CITY OF ALBUQUERQUE

**RE: Coors and Central
100 Coors Blvd NW
Permanent C.O. – Accepted
Engineer's Stamp Date: 01/16/18
Engineer's Certification Date: 05/31/19
Hydrology File: K10D017**

DRAINAGE AND TRANSPORTATION INFORMATION SHEET (REV 6/2018)

BEVERLY HILLS

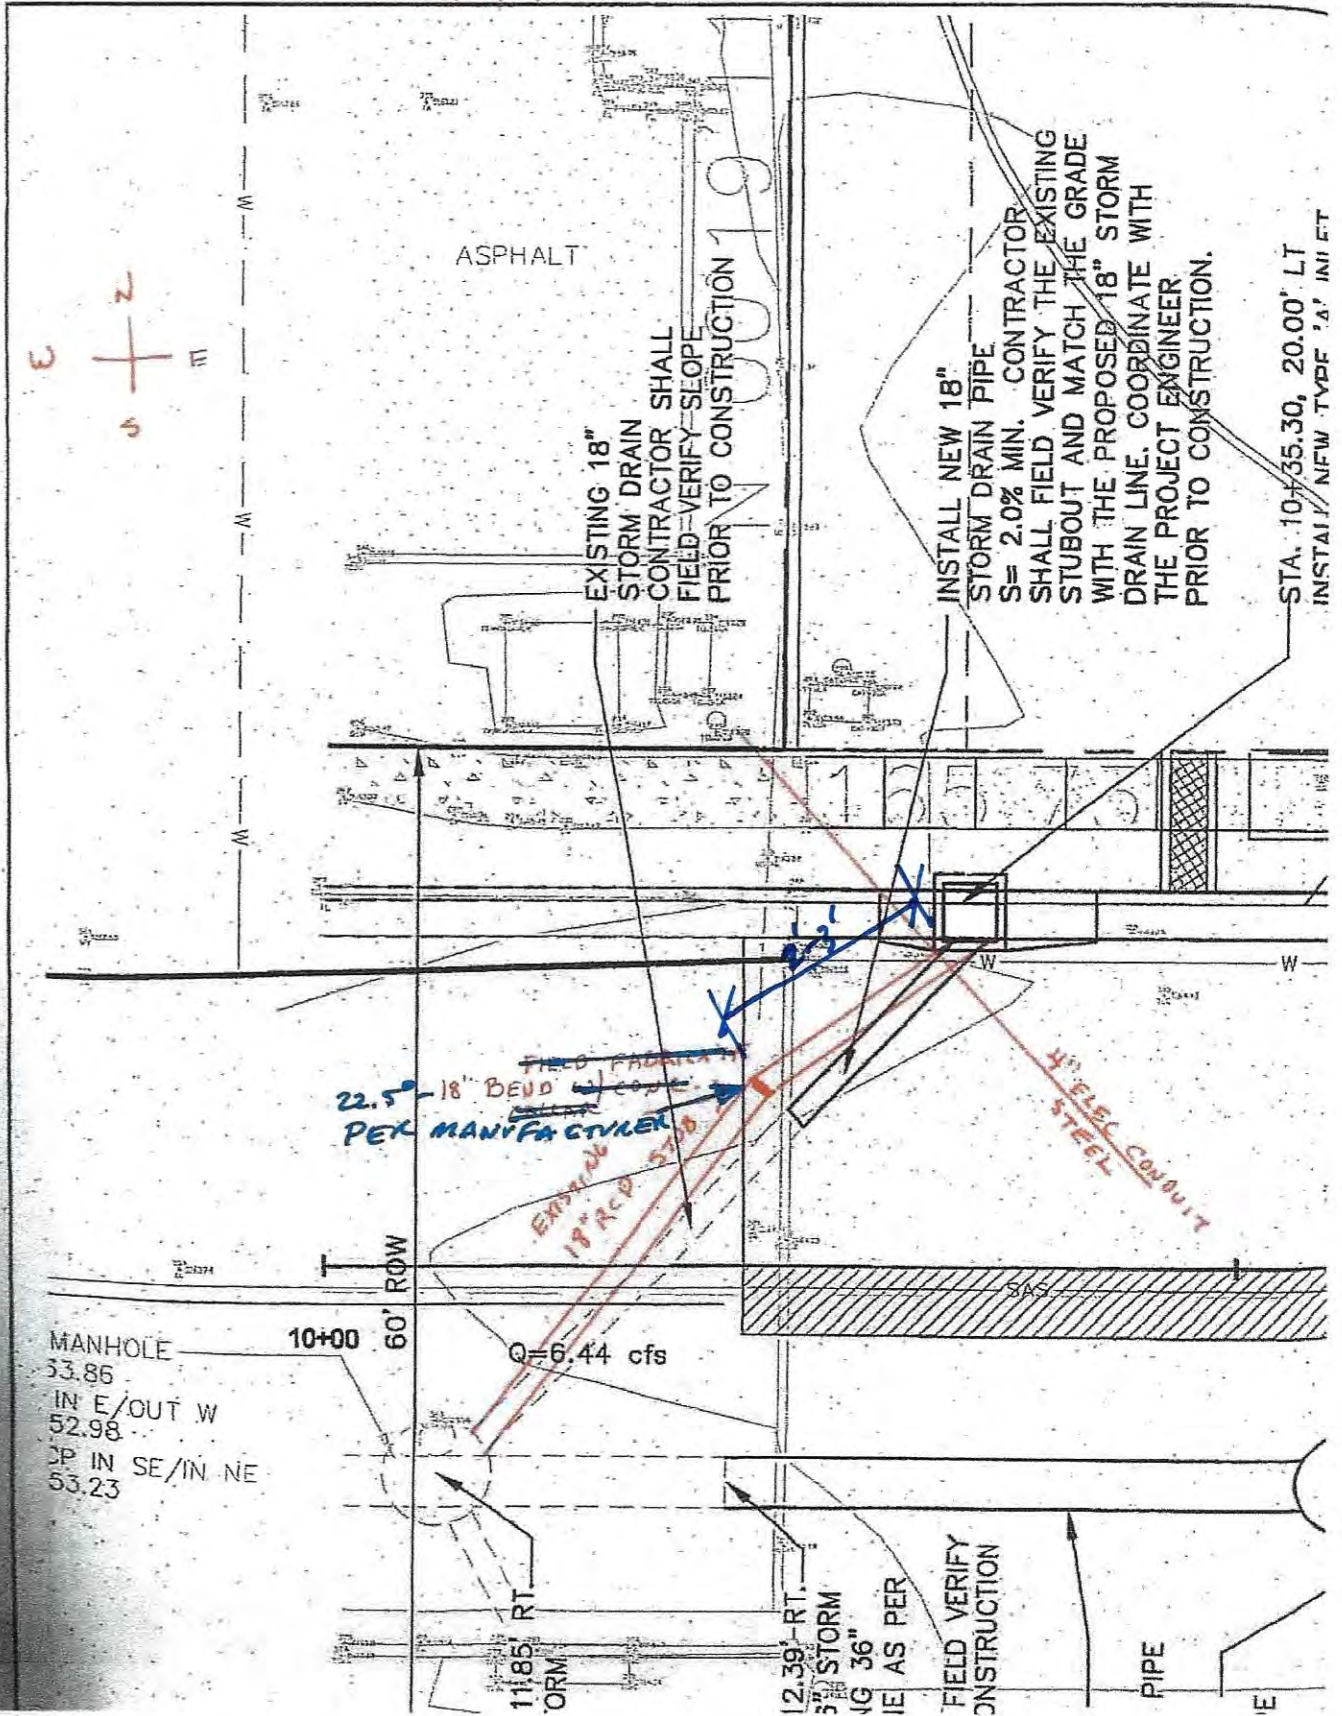
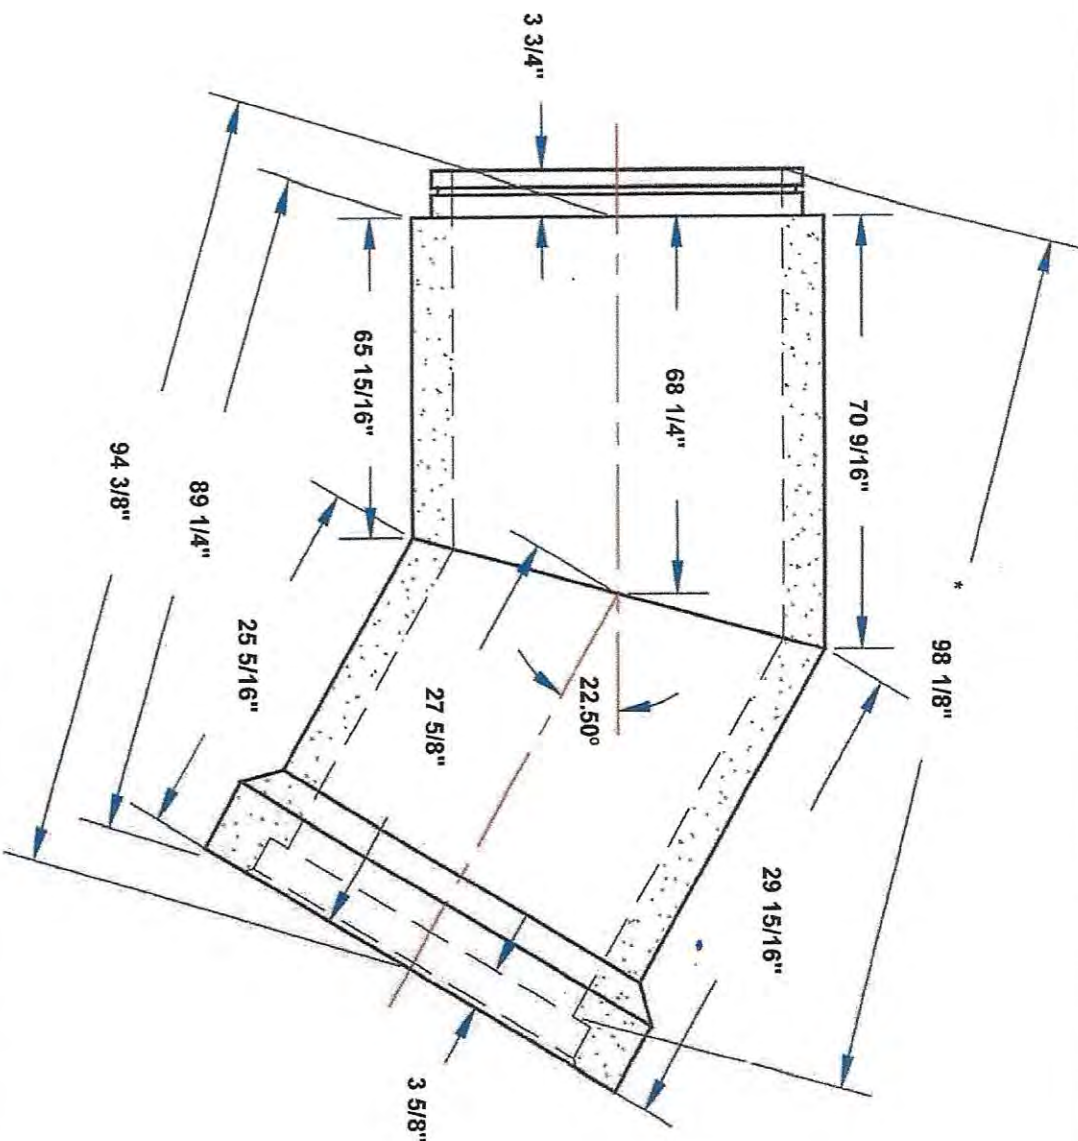
Attached is the proposed change by the contractor for a SD lateral that we discussed earlier and a picture showing the 4" steel casing that they are trying to avoid. We do not see any issues with hydraulic performance of the SD lateral given the peak flow anticipated at this inlet. Please let me know if the City concurs.

Attached is a photo of the Beverly Hills inlet conflict with the 4" steel conduit.

Attached is the City's design for bends. Please be aware that this is the draft DPM however, it is what the City has been enforcing for a while. If you have any questions, please give me a call.

Scale: N. T. S.	Dr. By: D. MOCEK
Date: 9/28/2018	Ck. By: E. NOBLES
1 Cut - 2 Piece BBRG Elbow Cut Sheet	
18"Ø / 2 1/2" Wall / CI-III / 22.5° RIGHT

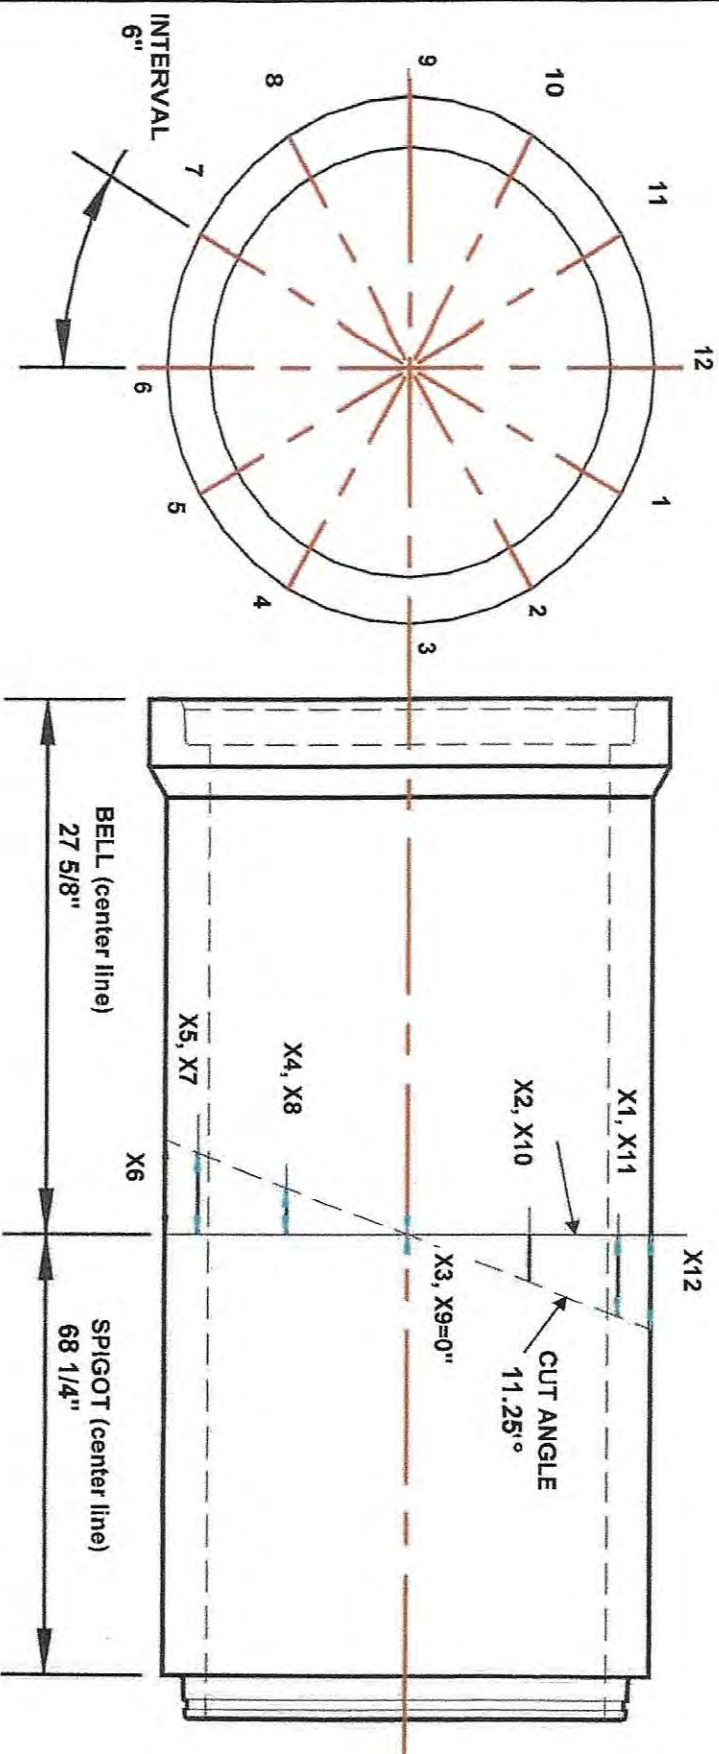
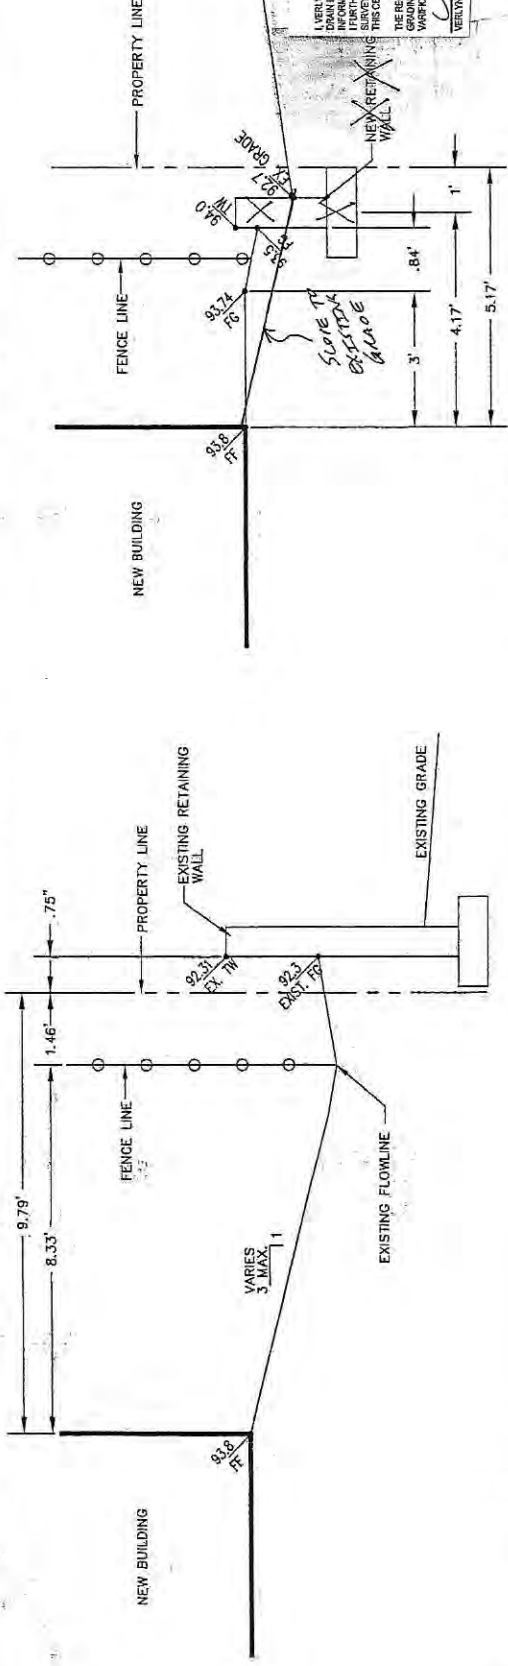
Please put the distance from both the existing MH and the proposed inlet to the bend on the sketch. One of these access points must be within 3 feet of the bend. Also is what they installed this Rinker bend? It does not appear so in the construction photo. Please verify for me.

I never received the sketch for storm sewer bend. Apparently the contractor has already installed this. This will not be accepted by the City until I receive the sketch that I have asked for since 9/17/18. I need to review it and give an approval for this prior to the acceptance of the storm sewer.

Verlyn, Hydrology was still waiting on a sketch for Beverly Hills per e-mail below before approval of bend. Show details (bend angle, manufacturer, etc.) If you could, call Renee to get her what she needs if you are unclear. Thanks!

Yes, a sketch of this would be great. This way I can add it to the project folder and please provide the name of the manufacture of the bend on the sketch.

This email will serve as an approval from Hydrology for the provided storm sewer bend information. If you have a question, please give me a call.

Attached is a revised sketch showing a dimension of 2-3 feet from the bend to the curb inlet.

Please see attached the sketch and premanufactured bend detail for the SD pipe lateral. Please let me know if this is acceptable.
